# Access Compliance Report

## Public Rights-of-Way

| Intersection ID: 14912 | Main Street: BUCHANAN_ST | Cross Street: WAVERLY_AV | Location: E            |
| ADA ID: 8A6ADE777B19   | Ramp Type: BlendTrans1   | Initial Pass/Fail: Fail  | Overall Compliance: No |

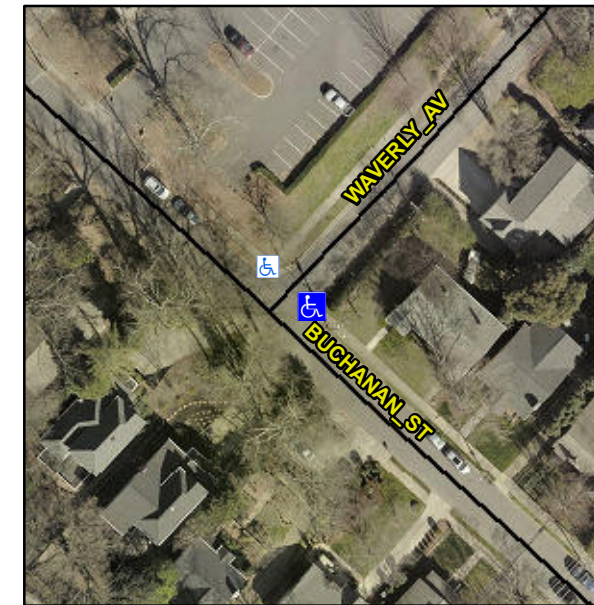
**Remove & Replace Curb Ramp With Two New Directional Ramps or Equivalent.**

**R304.5.1, R304.5.3**

| Compliance | Description           | Data  | Compliance | Description                 | Data  |
|------------|-----------------------|-------|------------|-----------------------------|-------|
| No         | Ramp Width (in)       | 46.0  | No         | BlendTrans XSlope (%)       | 3.5   |
